# VALUE ENGINEERING REPORT

US 23/SR 87 Widening and Reconstruction  
MLP-87 (45)  
Dodge and Bleckley Counties

December 3, 2007

Georgia Department of Transportation  
No.2 Capitol Square  
Atlanta, GA 30334

# SKETCH

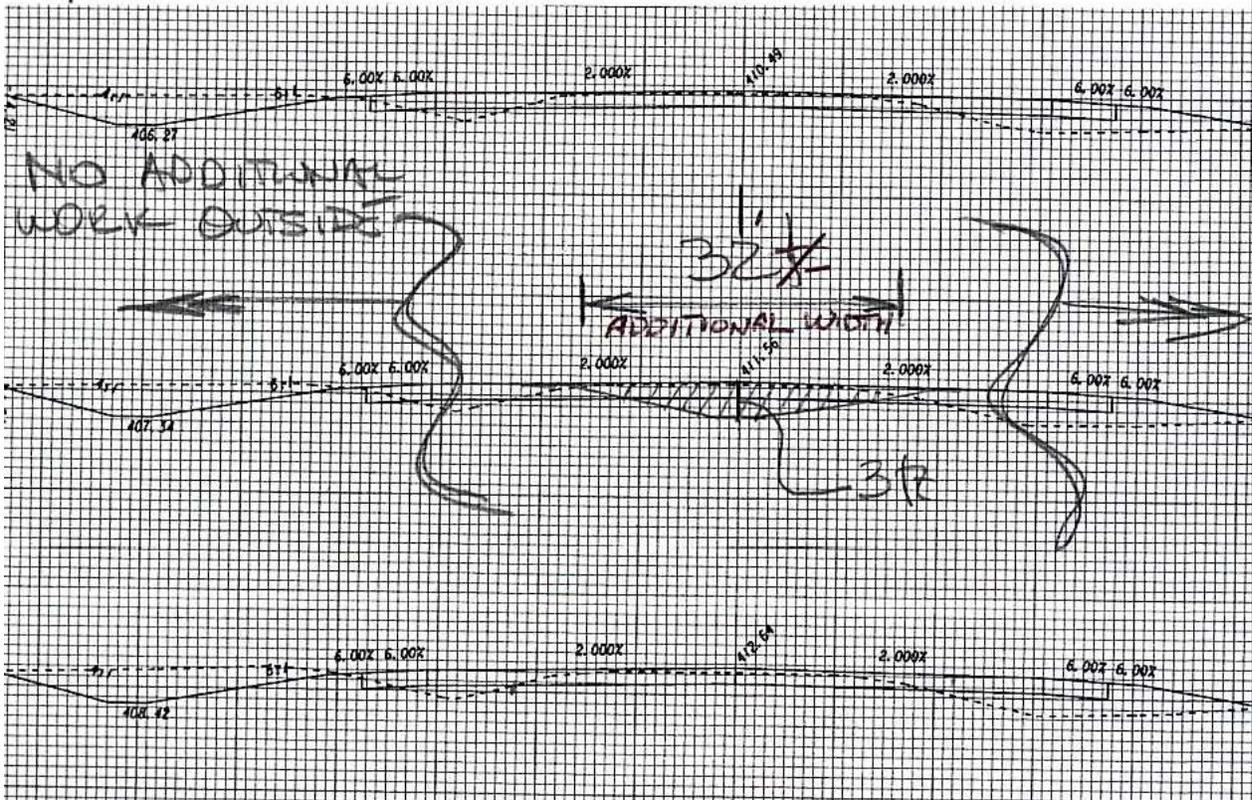
The baseline concept is to construct a 4400' section of roadway with a 14' flush median and rural shoulders.

The V.E. recommendation is to construct instead a 44' depressed median typical section in this area, as is proposed for other portions of the project.

This change would eliminate one of seven separate typical sections proposed for the project and provide a more consistent typical section with a 55 mph design speed. The adjoining property in this section of the project is undeveloped and R/W would be available and relatively inexpensive. Only one building is close enough to the roadway to be affected (Parcel 132), and it would appear to be impacted under the baseline concept. The railroad alignment is quite close to the roadway in this area, but that constraint could likely be mitigated with a modest shift in the horizontal alignment.

# SKETCH

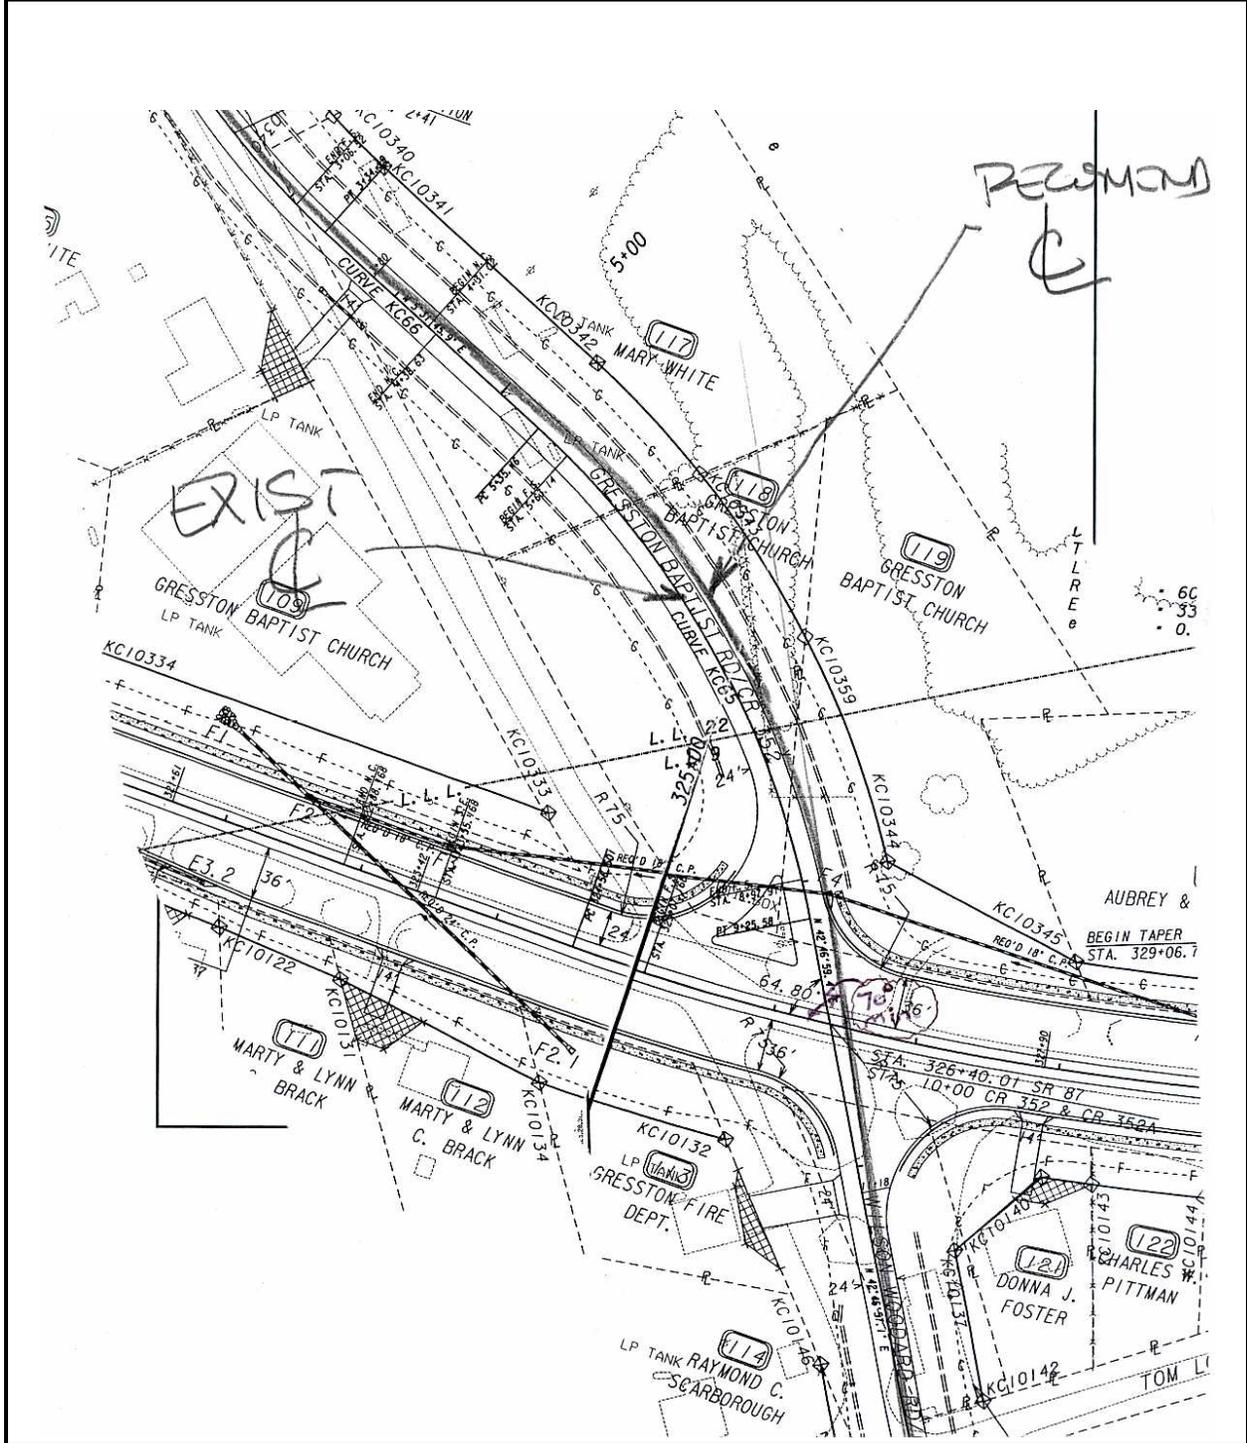
The skew angle proposed in the baseline plans is 64.8 degrees.

The VE Team recommends an adjustment of the alignments such that the skew angle will be a minimum of 70 degrees as required under GDOT design standards, thereby not requiring a D.V.

Note: After this recommendation had been prepared, the Team noted that a comment to this effect was included in the PFPR report. We were not sure if the Design Team intended to make this change and thus we decided to retain the recommendation to add our input to the issue. This revision would avoid the need for a design variance, and result in a safer intersection. An improved skew angle would also tend to move the crossroad farther from the church property which would be desirable for the church's future expansion plans as discussed during the kickoff meeting.
